12-08 LATEST REVISION DATE	<i>Thomas E. McQuinn</i> APPROVED BY BRIDGE ENGINEER	 Iowa Department of Transportation <i>Highway Division</i>	
		STANDARD DESIGN - 24' ROADWAY, 3 SPAN BRIDGES CONTINUOUS CONCRETE SLAB BRIDGES NOVEMBER, 2006	
		SUBDRAIN DETAILS	J24-42-06

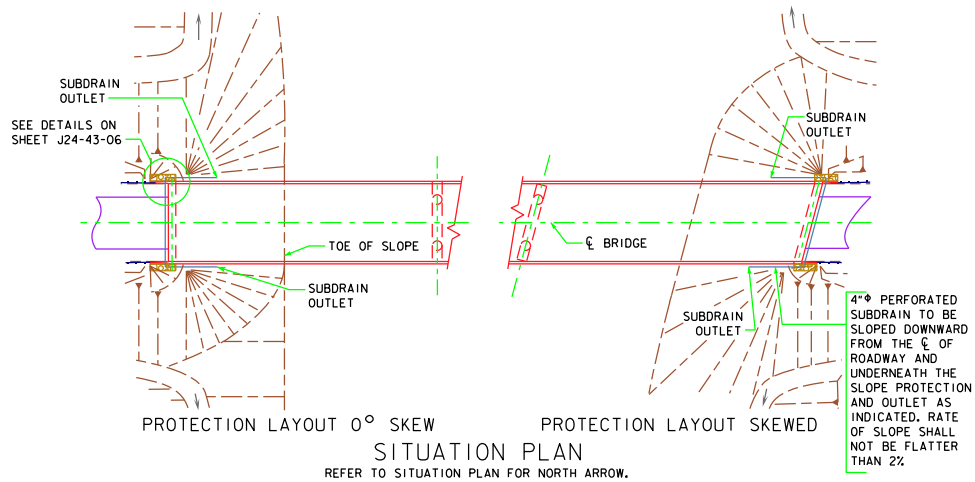
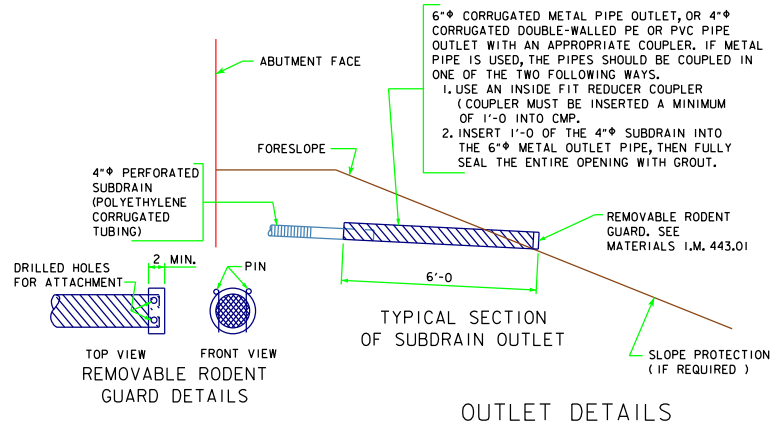
REVISED 12-08 - REMOVED GRANULAR BACKFILL DETAILS.
